ADDENDUM

Reference: Edge of Cedars Museum, New Roof
Division of Parks and Recreation
DFCM Project # 05091510

Subject: **Addendum No. 1**

Division of Parks and Recreation
New Roof for the Edge of the Cedars Museum,
Blanding, Utah
Project Number: 05091510

1 PARAPET WALL TOP FLASHING

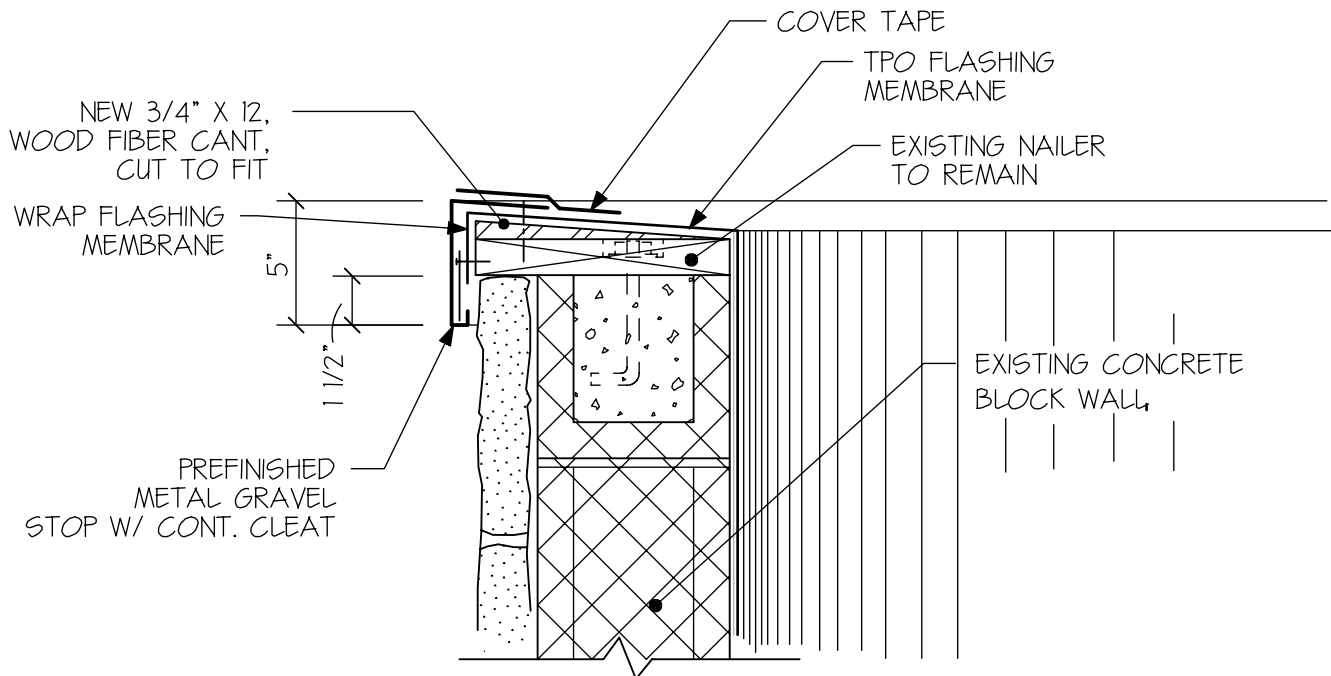
7. Details D4/A-501 and A4/A-501:
 - a. Detail D4/A-501 shall be replaced with Detail 1/AD-1.
 - b. Detail A4/A-501 shall be replaced with Detail 2/AD-1.
